TOWN OF NISKAYUNA
Planning Board and Zoning Commission
Agenda
May 23, 2022
7:00 PM

TOWN OF NISKAYUNA
Planning and Zoning Commission
Hybrid Meeting
Meeting Minutes
May 9, 2022

ITEM TITLE: RESOLUTION: 2022-10: A Resolution for site plan approval for a main entrance and dining room addition to the Glen Eddy at 1 Glen Eddy Dr.

ITEM TITLE: RESOLUTION: 2022-11: A Resolution for site plan approval for sidewalk improvements including the addition of an ADA ramp at 3333 Consaul Rd.

SITE LAYOUT PLAN

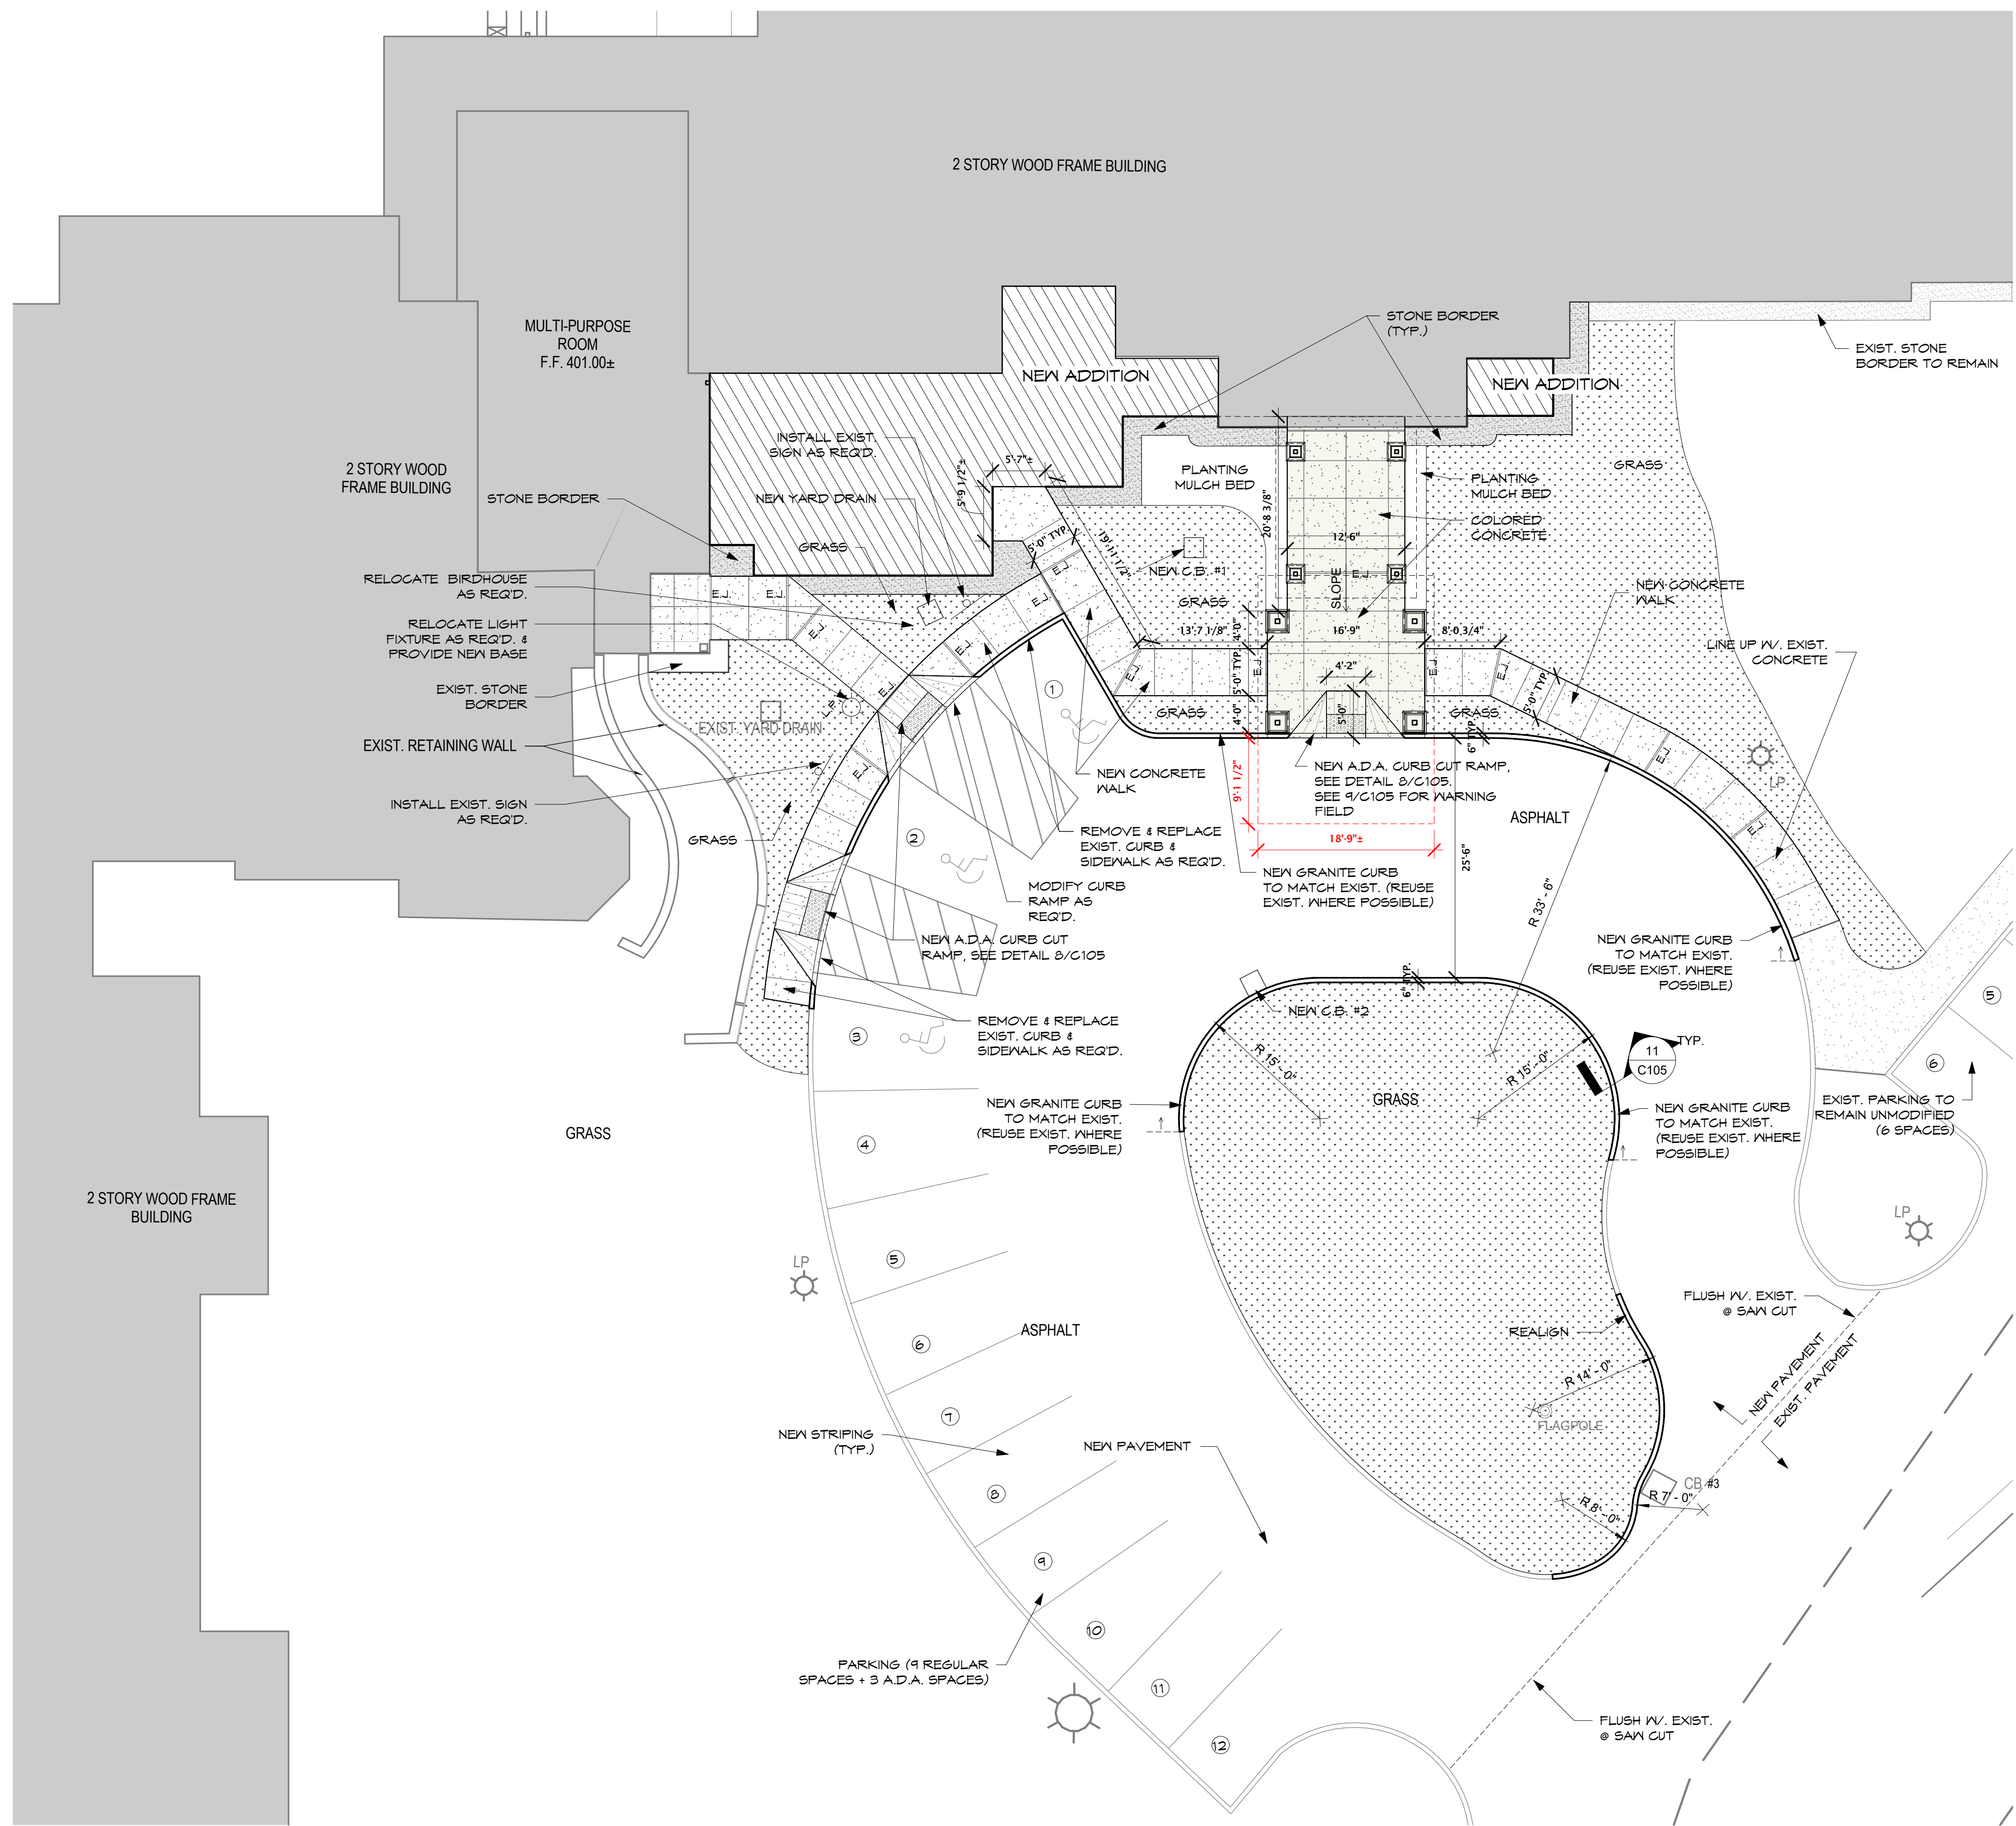
The Fire Department reviewed the project and noted a ladder truck cannot fit under the canopy – so the engineers should ensure fire response vehicles have room to drive around the roof canopy (a full other lane).

SITE PLANTING PLAN

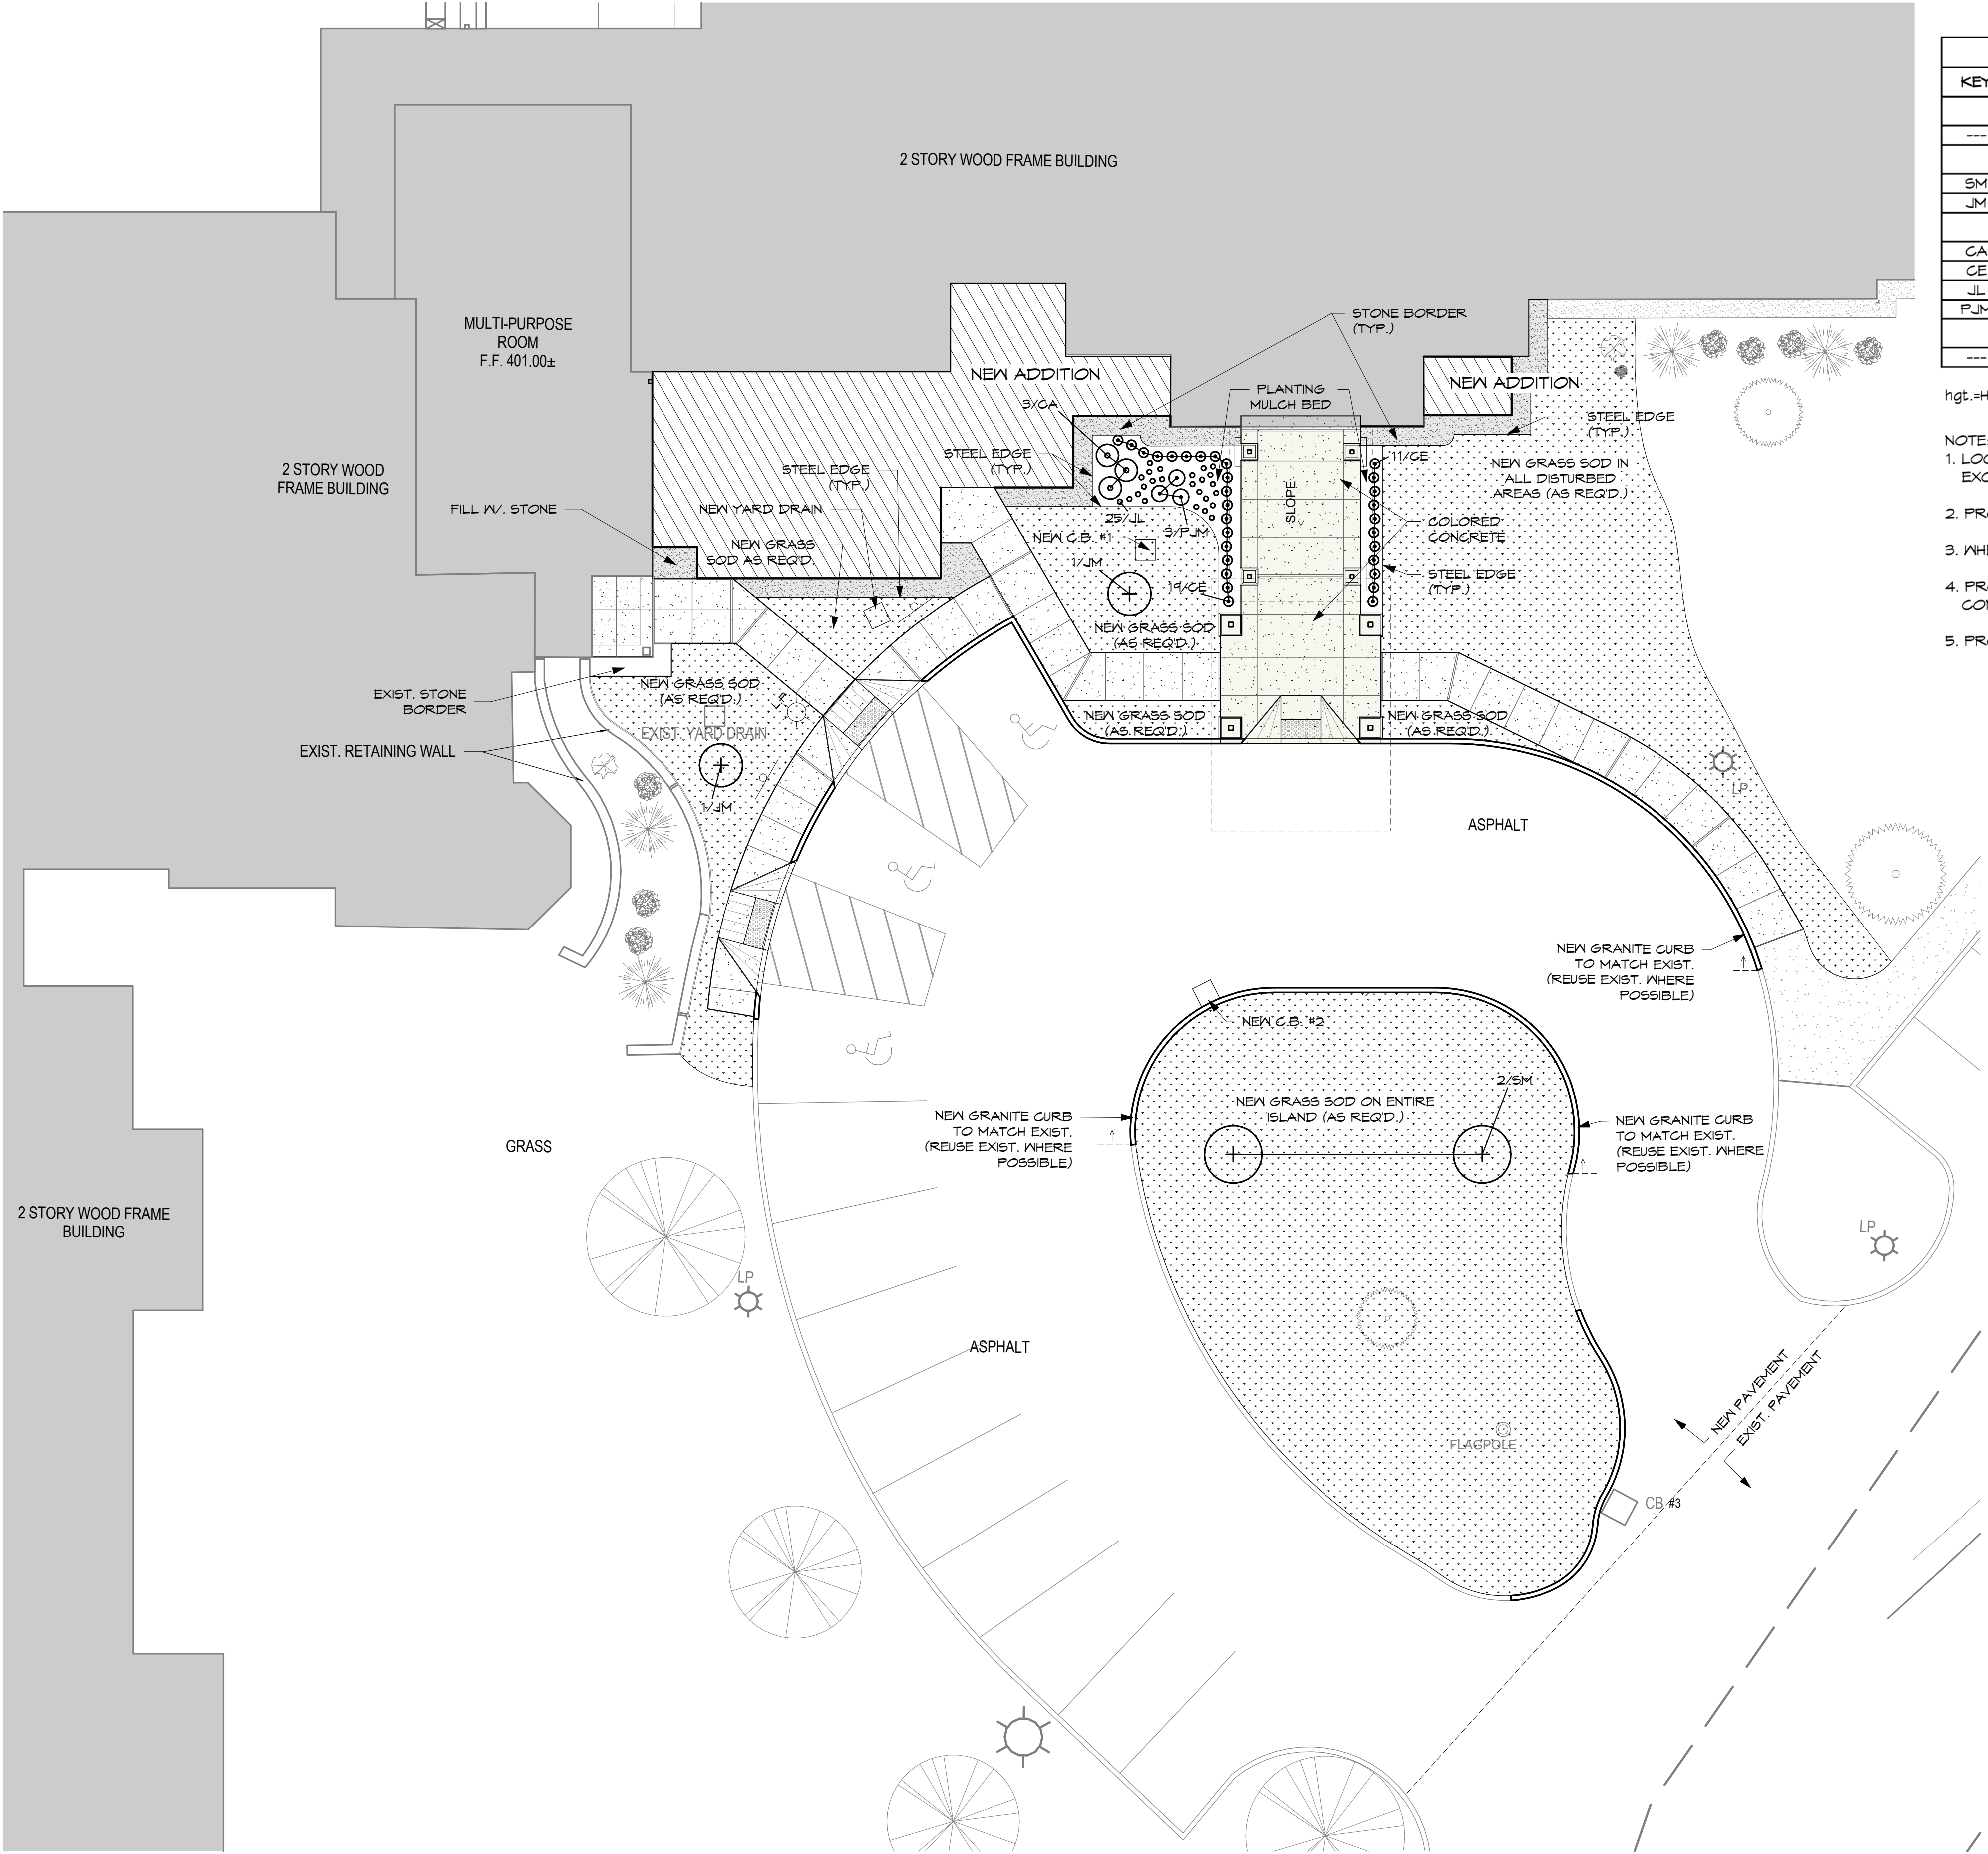
1. Prior to issuance of a building permit the Niskayuna Tree Council is to review and approve the proposed Planting Plan.
2. Prior to issuance of a building permit the Niskayuna Architectural Review Board (ARB) is to review and approve the site plan and renderings for the proposed addition.
